Safety Defect and Noncompliance Report Guide for Vehicles

Furnish the manufacturer's identification code for this recall (if applicable): NHTSA recall # 06E-093

Generic name of the item: SOLID BAR LINKAGE ON WHEELCHAIR LIFT

SOLID BAR LINKAGE REPORT

DOC NO 123-0287

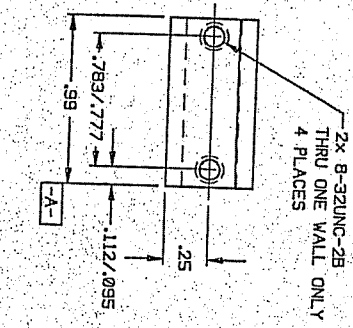
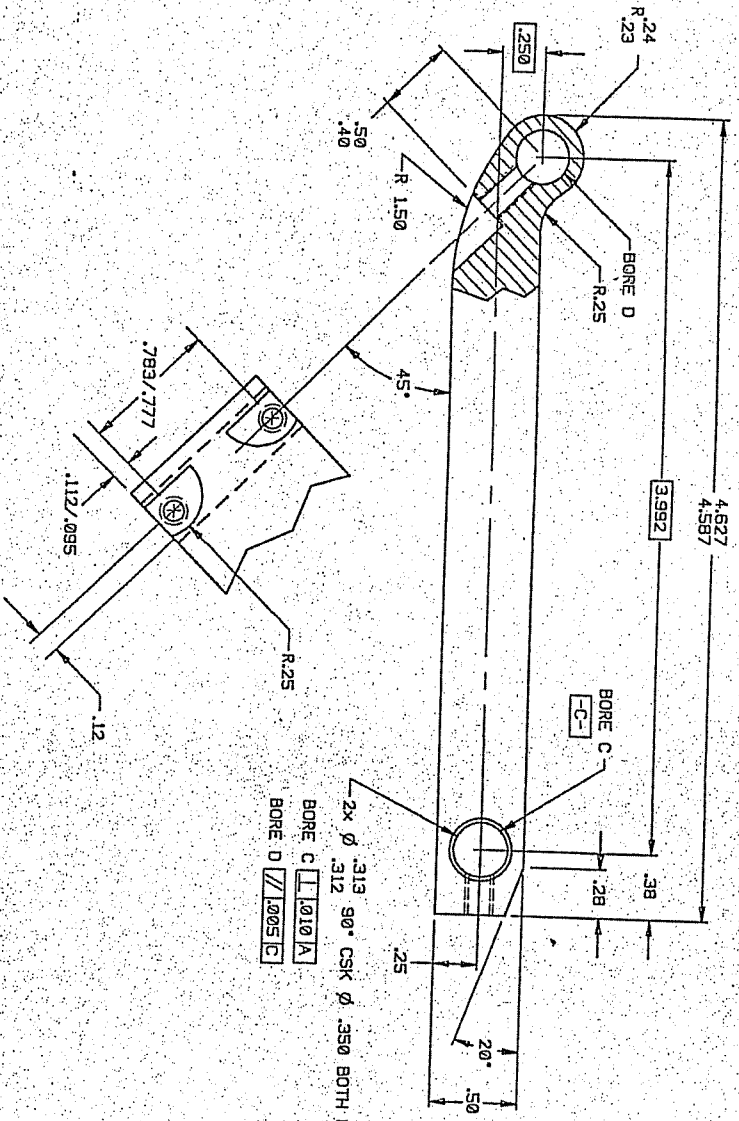
Other information which characterizes/distinguishes the items of equipment to be recalled:
PARTS 184-0042, 184-0041, 123-0288 AND 123-0287 WHICH MAKE UP
THE SOLID BAR LINKAGE AS SHOWN ON ASSEMBLY DRAWING 184-0060
